CLD-A100

SERVICE INFORMATION

No. : SI-V48056

#	DETAIL OF CHANGE(S)	#	REASON FOR CHANGES
1	Addition of seals to the flexible cable	1	To protect the cable from burrs on its cable

FTSB Assy

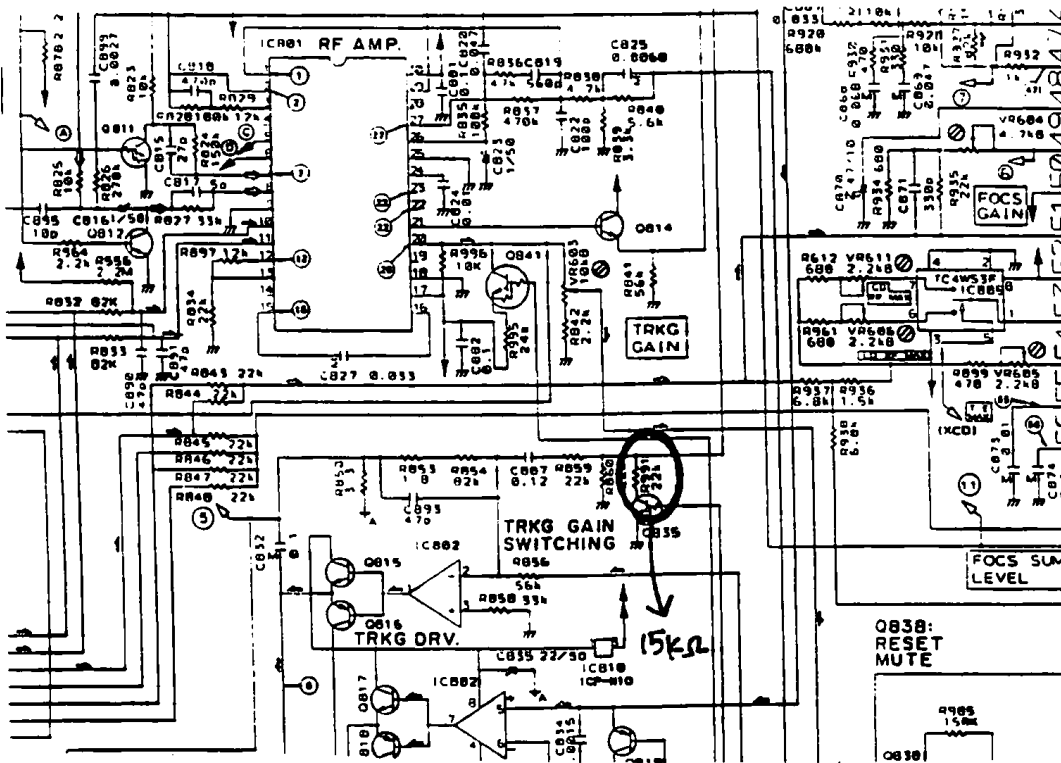
#	DETAIL OF CHANGE(S)	REASON FOR CHANGES
1	Change of a resistor in FTSB Assy	To improve playability

Ref.	CURRENT PARTS		CO	NEW PARTS	
#	SYMBOL/DESCRIPTION	PART NUMBER	DE	PART NUMBER	SYMBOL/DESCRIPTION
A 1	R991 (22kΩ)	RS1/10S223J	2	RS1/10S153J	R991 (15kΩ)

[Fig. 1]

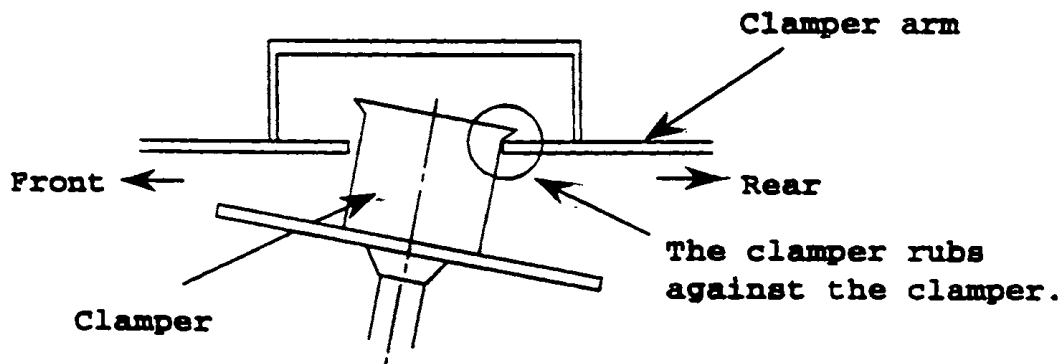
#	DETAIL OF CHANGE(S)	REASON FOR CHANGES
1	Change of the shape of Chassis	X To prevent mechanical noise from being audible when an LD disc is played
2	Change of Rear panel and Front stay, and deletion of spacers

<PROBLEM> Mechanical noise is audible when an LD disc is played.

<CAUSE> When an LD disc is clamped, the motor center axis is slanted due to:

- The height of the mech mounting portions on the Chassis is lower by 0.5mm.
- The mounting position of the mechanism is deviated toward the rear side.

Therefore, the clamper rubs against the clamper arm at the rear side.

Ref.	CURRENT PARTS				NEW PARTS	
	* #	SYMBOL/DESCRIPTION	PART NUMBER	CODE	PART NUMBER	SYMBOL/DESCRIPTION
B 2	Rear panel	(NSP)	-	DNA1135	Rear panel	
B 2	Front stay	DNE1207	-	(Unchanged)	Front stay	
B 2	Spacer	DEC1743	-	Deleted

[Fig. 2]

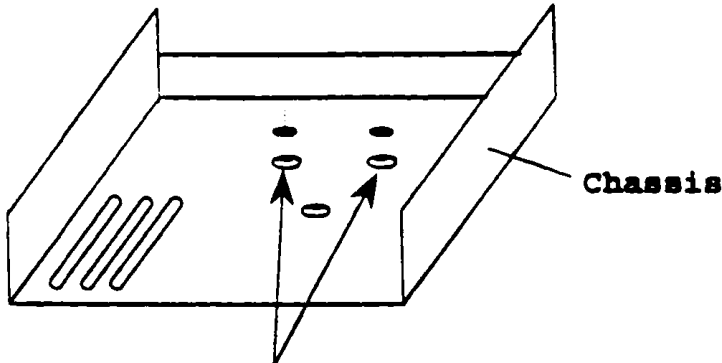
1. Stick 1 or 2 spacers (DEC1743) to the mech mounted portions of the chassis. (See Fig. 2) (One spacer has already been stuck there from the 1st production.)
2. If mechanical noise remains after the spacers are stuck, replace the rear panel and the front stay with the new parts (DNA1135 & DNE1207).

Stick one or two spacers (DEC1743) to these portions.

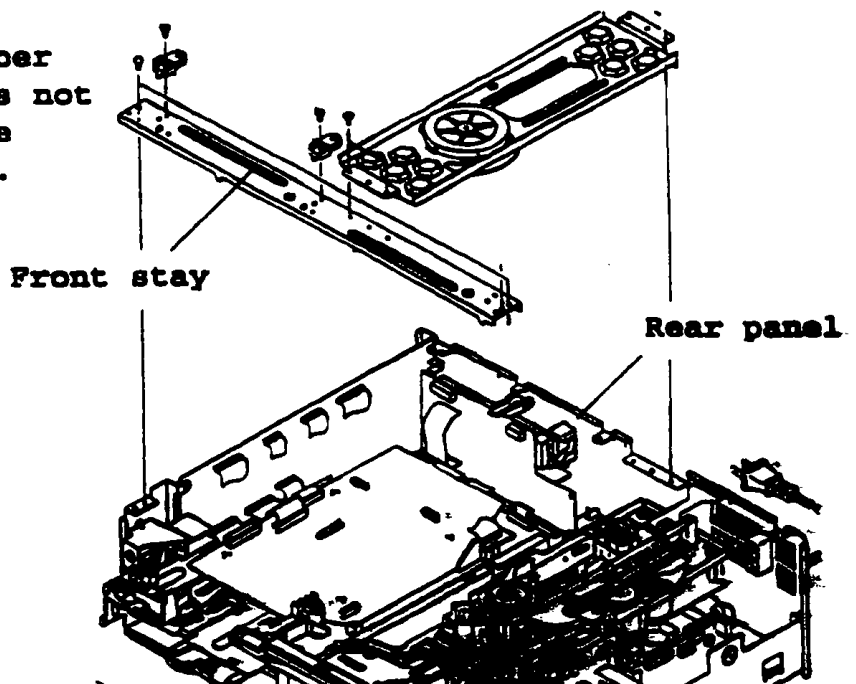
- 1) Improved the shape of the chassis.
- 2) Changed Rear panel and Front stay, and deleted spacers from the chassis.

Rear panel:	N.S.P.	---	>	DNA1135
Front stay:	DNE1207	---	>	DNE1207*
Spacers (x4):	DEC1743	---	>	Deleted

FIG.3:VIDEO ASS'Y-PARTS MOUNTED SIDE

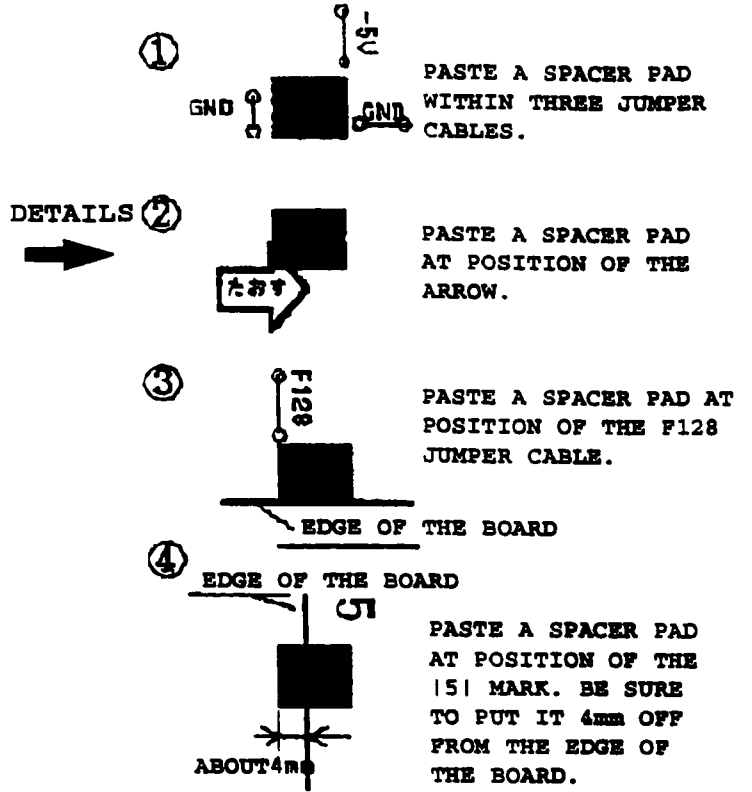
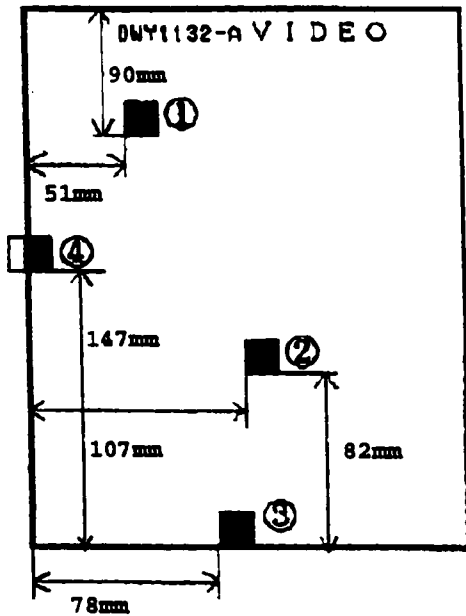
<PROBLEM> THE 12 INCH DISC GETS SCRATCHED WITH A CIRCULAR MARK.

<CAUSE> DUE TO CLOSE DISTANCE BETWEEN THE DISC AND VIDEO ASS'Y IN THE DISC CLAMPED STATUS, PARTS (CAPACITORS, ETC.) MOUNTED ON VIDEO ASS'Y CONTACT WITH THE DISC WHEN A SHOCK IS APPLIED TO THE UNIT DURING PLAYBACK, CAUSING A CIRCULAR SCRATCH ON THE DISC.

<SERVICE REMEDY> PLEASE ADD FOUR SPACER PADS ON THE PARTS MOUNTED SIDE OF VIDEO ASS'Y TO PREVENT A SIGNAL RECORDED AREA OF THE DISC FROM BEING SCRATCHED WITH A PROTECTIVE CONTACT OF THE DISC EDGE WITH THE SPACER PADS.

PARTS INCLUDED IN THE KIT: ① - ③ REB1187 (WITH ADHESIVE TAPE) X 3
 ④ DEB1044 (WITH ADHESIVE TAPE) X 1

*NOTE (1) PLEASE LOCATE A SPACER PAD WITHIN $\pm 1.0\text{mm}$ IN TOLERANCE.

(2) AFTER PASTING A SPACER PAD ON THE BOARD, PLEASE APPLY THE SILICONE ADHESIVE (GYL-1002) AT TWO POSITIONS OF THE PAD AS SHOWN RIGHT. ALSO, PLEASE ASSEMBLE BOARDS INTO THE UNIT AFTER THE ADHESIVE GETS DRY.

[FIG.1: AUDIO MIX CIRCUIT OF SSUB ASSY]

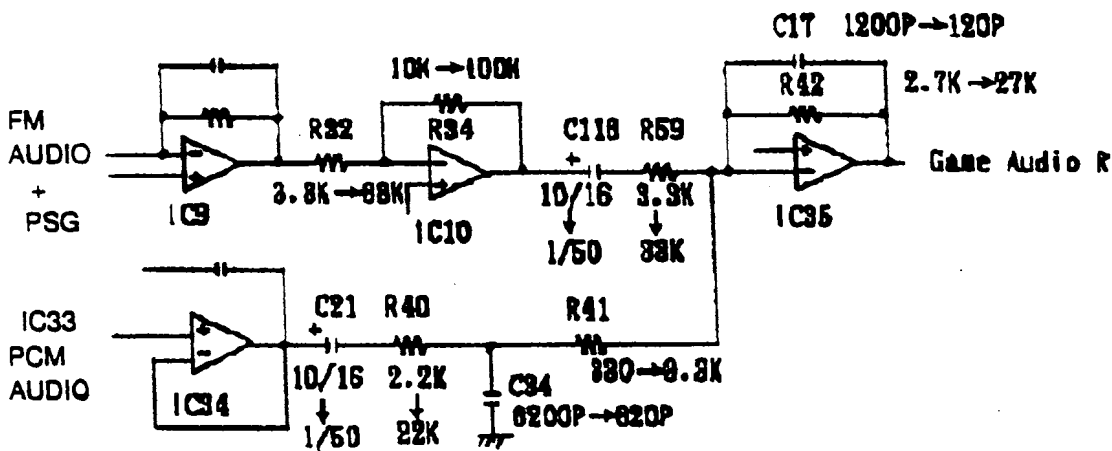
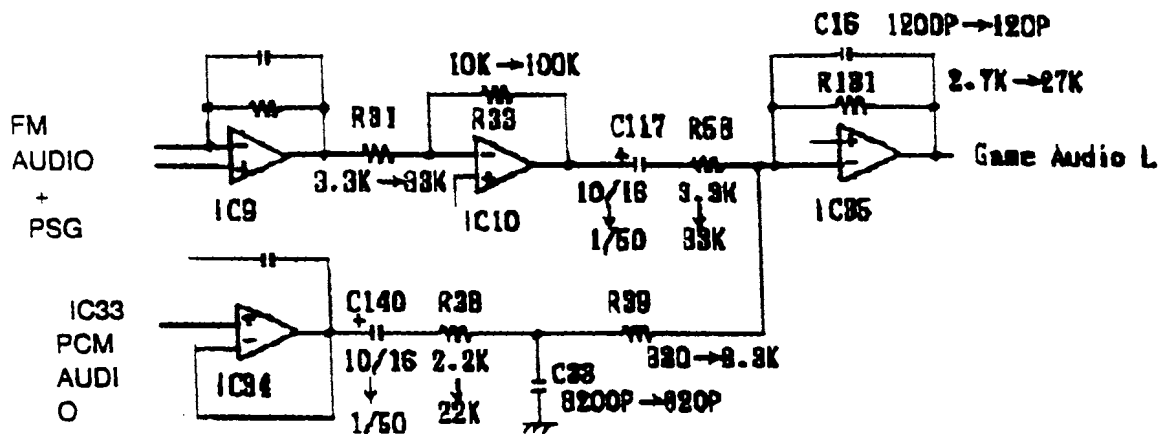
MODEL NO.	*	SER. NO.	MODEL NO.	*	SER. NO.	MODEL NO.	*	SER. NO.
PAC-S10/ZU	A	6919901-						
#	DETAIL OF CHANGE(S)				REASON FOR CHANGES			
1	CHANGE OF AUDIO MIX CIRCUIT				X	TO PREVENT HIGH FREQUENCY AUDIO OF GAME SOFTWARE FROM BEING DISTORTED		
<p><PROBLEM> WHEN A CERTAIN SEGA GAME SOFTWARE IS PLAYED, HIGH FREQUENCY AUDIO IS DISTORTED.</p> <p><CAUSE> IN CASE THE RECORDING LEVEL OF A SEGA GAME SOFTWARE IS HIGH IN AUDIO, AUDIO OUTPUT FROM OP-AMP (SSUB ASSY:IC10) IS DISTORTED DUE TO HIGH CURRENT OPERATION OF THE AUDIO MIX CIRCUIT.</p> <p><NOTE> SINCE YOU HAVE NO SCHEMATICS IN THE SERVICE MANUAL, PLEASE JUST TAKE THE SERVICE REMEDY IN THE FOLLOWING PAGE AS YOUR INFORMATION FOR THE CUSTOMER'S COMPLAINT ON A CERTAIN SEGA GAME SOFTWARE.</p>							SERVICE MANUAL	
							MODEL :PAC-S10	
							S/M NO.:ARP2779	
							PAGE :2	
Ref.	CURRENT PARTS			CO	NEW PARTS

PLEASE MODIFY THE AUDIO MIX CIRCUIT AS SHOWN BELOW.
